## Amendments to the classification of desensitized explosives according to the GHS

Transmitted by the experts from Germany and the United States of  
America\*

### Proposed amendments to Chapter 2.17 of the GHS and Section 51 of the Manual of Tests and Criteria

*Decision logic 2.17.1 for desensitized explosives*

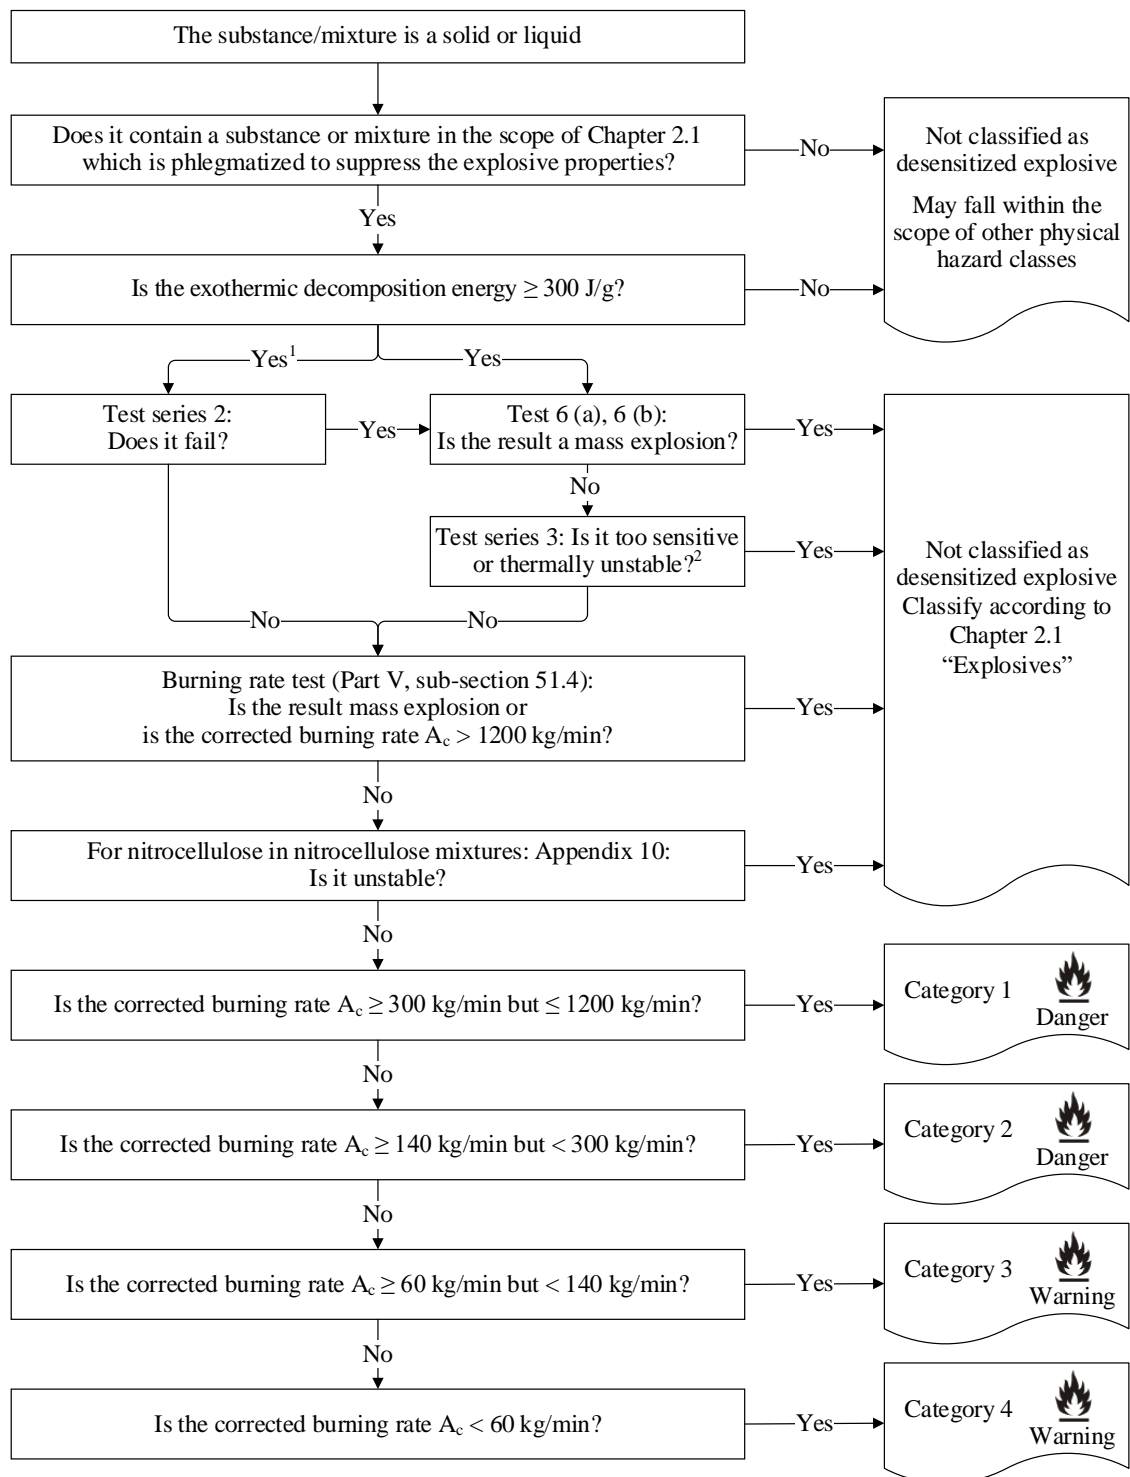
Decision logic 2.17.1 Replace with the following:

Insert the following footnotes:

<sup>1</sup> Test series 2 is optional. The alternative route (via test 6 (a) and (b) and test series 3) may be taken directly without performing test series 2.

<sup>2</sup> Test series 3 is not applicable to nitrocellulose mixtures containing no other explosives than nitrocellulose.
